**Re: Petition 1347 - GRE GACRUX LLC Petition for a Declaratory Ruling, Pursuant to Connecticut General Statutes §4-176 and §16-50k, for the Proposed Construction, Maintenance and Operation of a 16.78 MW AC Ground-mounted Solar Photovoltaic Electric Generating Facility Located on Oil Mill Road in Waterford, Connecticut**

**Petition No. 1347**

**RESPONSE OF GRE GACRUX LLC TO INTERROGATORIES PROPOUNDED BY  
SAVE THE RIVER - SAVE THE HILLS, INC.**

### Appendix I Attachment 1 Solar Panel Installation Schematic

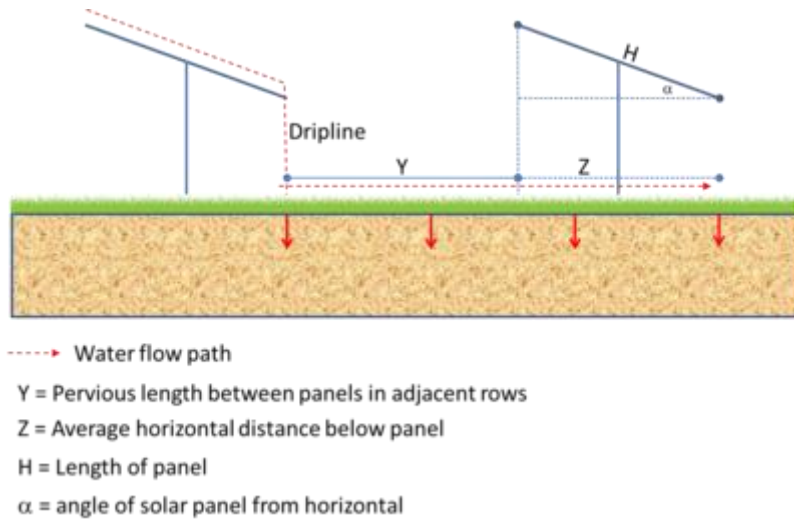
1. Reference page 4 of the Stormwater Management Report, which is dated June 8<sup>th</sup> 2018, and included in Volume 3 of the above-captioned Petition(the “Report”). Please explain how gravel driveways and solar panels could be considered not impervious.

- (a) The vegetated area receiving runoff between rows of solar panels (dimension Y in Attachment 1) is equal to or greater than the average width of the row of solar panels (dimension Z in Attachment 1) draining to the vegetated area.
- (b) Site conditions shall be maintained such that the runoff remains as sheet flow across the entire site. At a minimum, slopes greater than 5% shall include engineered practices such as, but not limited to, level spreaders, terraces or berms to ensure long term sheet flow conditions.
- (c) The solar panels are constructed in such a manner as to allow the growth of vegetation beneath and between the panels.

**Response:** Members of the Project team met with CT DEEP staff on May 2, 2018. Those in attendance at the meeting were Jean-Paul LaMarche of GRE, Lee Hoffman Esq. from Pullman & Comley, LLC, John Schmitz and Mike Sullivan from BL Companies, and Sharon Yurasevecz, Neal Williams, and Oswald Inglese from Connecticut Department of Energy and Environmental Protection (“DEEP”) Water Permitting and Enforcement. At the meeting, it was determined that in order for the array field to be considered pervious, the Development would utilize minimum panel row dimensions of 14.5 feet, which corresponds to the “Y” dimension referenced in Attachment A below.

This determination was made, in part based on the information found in the State of Minnesota's Stormwater Manual, a relevant portion of which is included as Attachment A to these responses. The DEEP representatives at the meeting indicated that DEEP is currently using the Minnesota standards as guidance, until such time as DEEP can compile sufficient rainfall information in Connecticut for use in its manual.

As Attachment A indicates, a solar project may be considered pervious if the following three conditions are met:

The Project, as designed, will meet all three of these conditions, and can therefore be considered pervious, pursuant to GRE's discussions with DEEP staff and pursuant to the guidance documents upon which DEEP staff relies to make its decisions.
